REQUEST FOR INFORMATION

RFI NUMBER	NL-RFI-051
ISSUE DATE (YY/MM/DD)	July 13, 2011
PRIORITY	H <input type="checkbox"/> M <input checked="" type="checkbox"/> L <input type="checkbox"/>
REQ'D RESPONSE DATE	July 18, 2011

Hope Bay Mining Project

Subject:	Doris Diversion Berm Liner Detail	Project Zone/Area:	Doris North Diversion Berm
Company:	Nuna Logistics Ltd. (Nuna)	Station/Location:	Middle Pad Extension
Attention:	Calvin Goldschmidt	Discipline:	Civil

Proposed HDPE Liner Installation
 Doris North Diversion Berm - Middle Pad Extension
 Prepared by: Nuna Contracting Ltd.
 July 13, 2011
 Reference:
 SRK IFC DN-DMC-027 (HB+D-CIV-CIV-OND-0123) Revision 0
 Section B - Typical Pad Extension Section

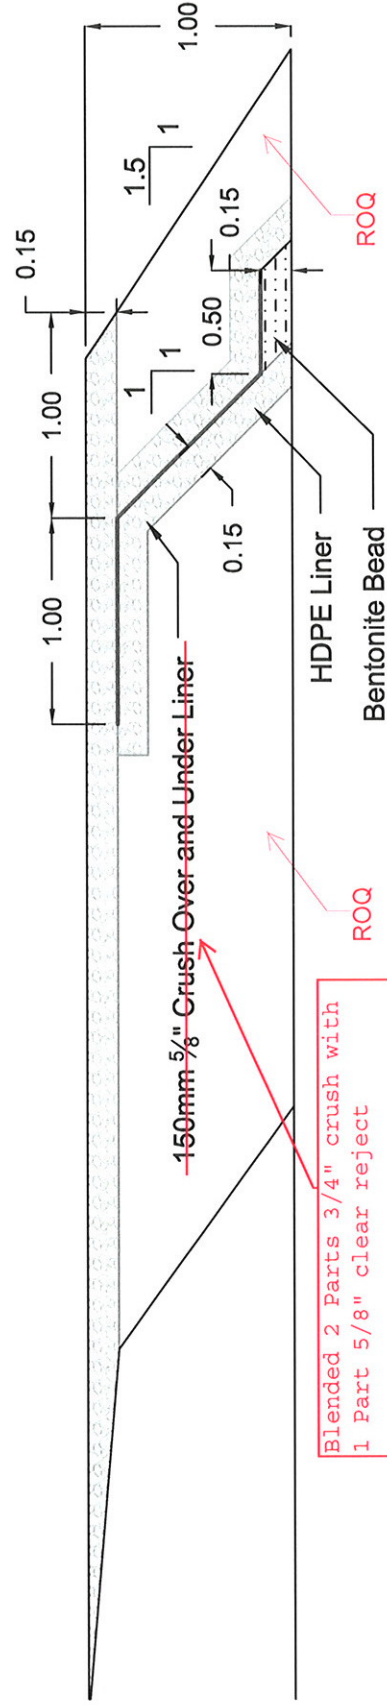
Information Request/Description of Issue/Approval Required:
The Doris North Diversion Berm – Middle Pad Extension scope has been revised to include an HDPE liner. Nuna proposes to install the liner on a 1:1 slope, a minimum of 1 meter from the shoulder of the pad extension, with bentonite bedding according to the attached design sketch.

Proposed Corrective Action:	
Provide approval to proceed with the Nuna proposed liner installation.	
Originator: Jeff DePape	July 13, 2011
Print: 	Sign: 
	Date:

Response:	
SRK accepts the proposed Doris North Diversion Berm - Middle Pad Extension HDPE liner installation design with one modification. The blended 2 parts 3/4" crush with 1 part 5/8" clear reject should be used as under and over liner granular material. This blended material was used under the liner at the Doris North landfarm and would reduce the risk of liner puncture. SRK would caution placing over-liner granular material on the 1H:1V slope may be a challenge.	
Responsible Newmont Representative: Lowell Wade	July 14, 2011
Print: 	Sign: 
	Date:

Blended 2 Parts 3/4" crush with
 1 Part 5/8" clear reject
